Field Inspection Report

Riverside Apartments · Annual Structural Inspection

Fig. 1

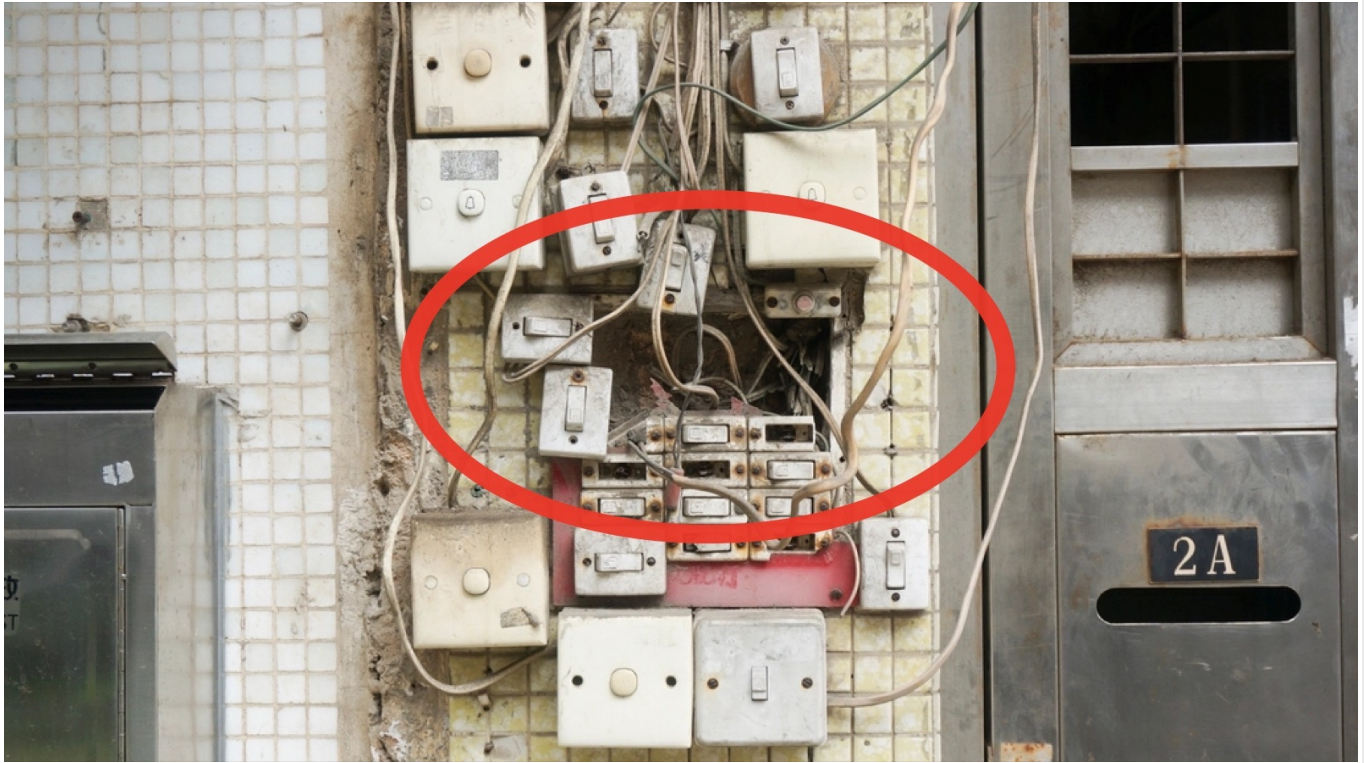
Several conductors are exposed at the corridor junction box and the cover plate is missing, an electric-shock hazard. Circuit isolated; a licensed electrician will reinstate the cover and terminate the conductors.
